Percolation Certification Plan

Purpose: REVISED SEPTIC FIELD

**Purpose: REVISED SEPTIC FIELD
SEPTIC TANK RELOCATION**

PROJECT NAME:
SINGLE-FAMILY DWELLING
6825 GREEN HOLLOW WAY
HIGHLAND
LOT 15
HOWARD COUNTY
MARYLAND

Percolation Certification Plan

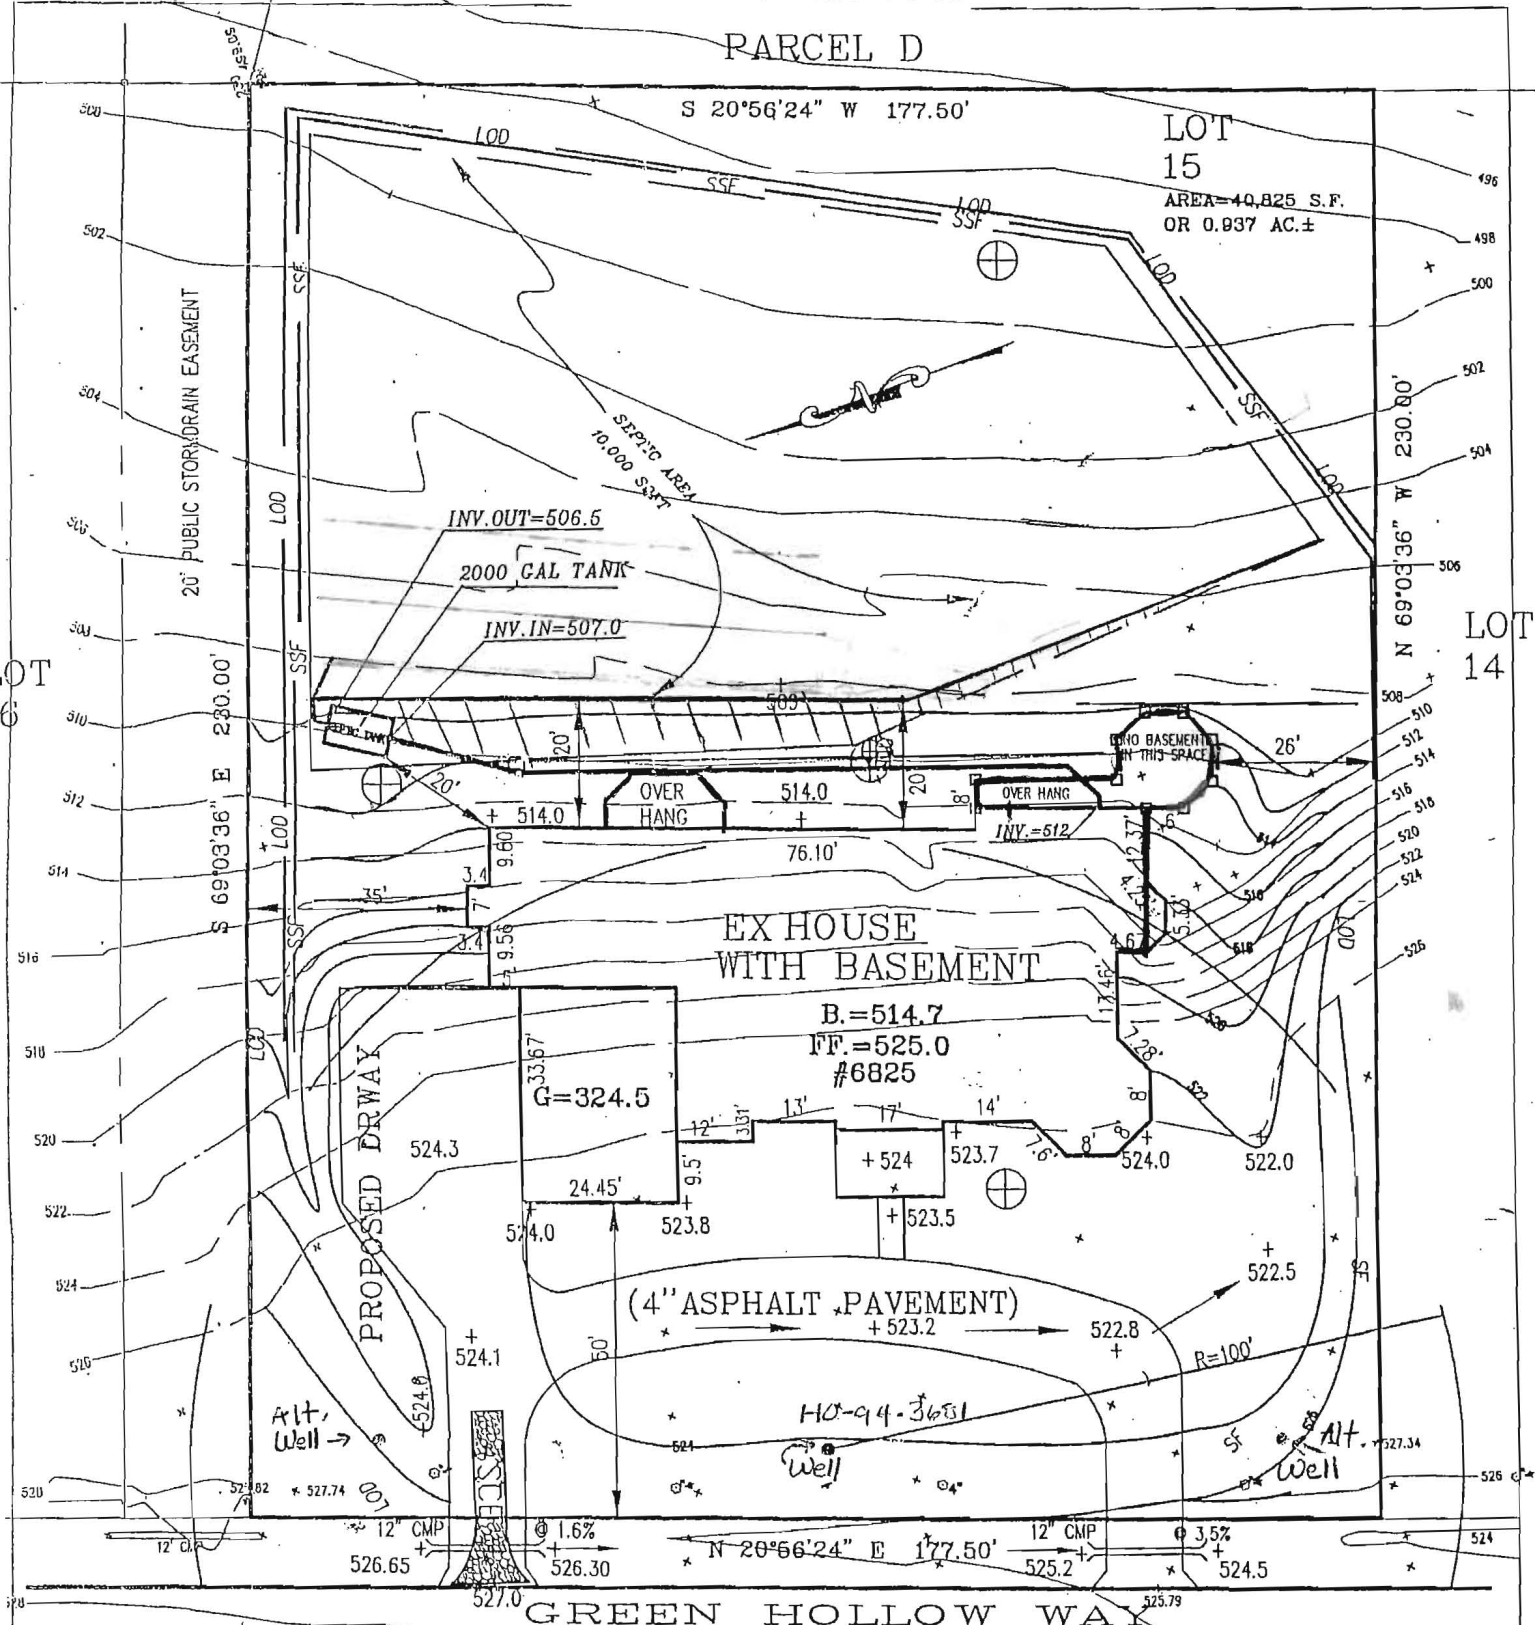
PROPOSED ELEVATION:
TOP OF BASEMENT SLAB: 514.7
TOP OF FIRST SUBFLOOR: 524.7
INVERT OUT OF HOUSE: 512.0
INVERT INTO TANK: 507.0
INVERT-OUT OF TANK: 506.5

Percolation Certification Plan

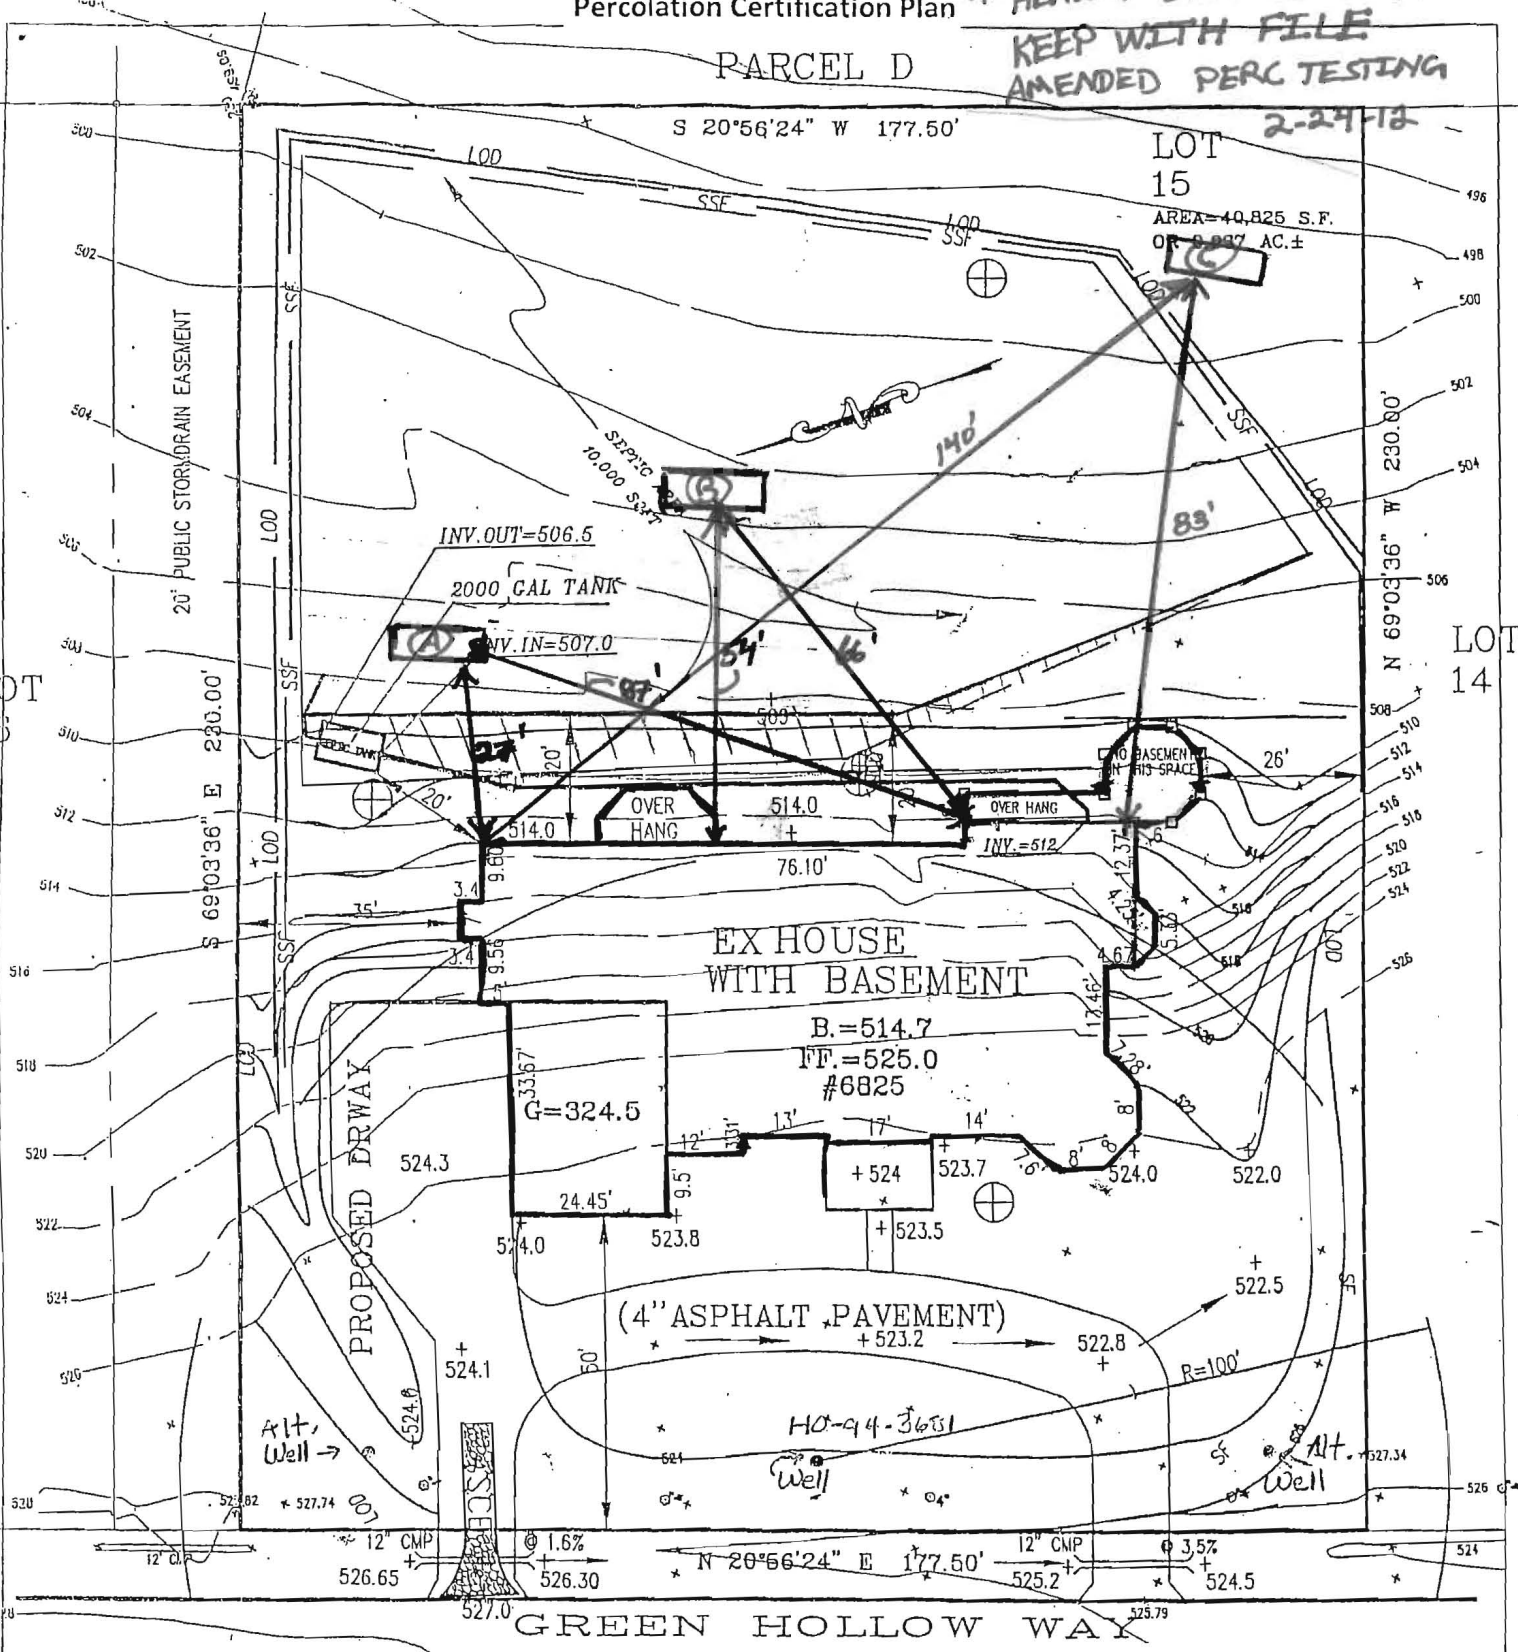
1. Eagles will not move the stockpile of deposit or dirt outside the LOD as the complete septic const.
2. The stockpile will be removed after septic construct but before health approval. A path will be made along the right side of house to allow loaders to carry the pile to trucks at the street. All activity to be done inside LOD. A silt fence will be created around the septic components during removal.
3. Health dept. will approve final grading before approval of septic

- Re-establish a new plan showing what's existing,
- Retaining wall? TMA elevations? may need to raise?
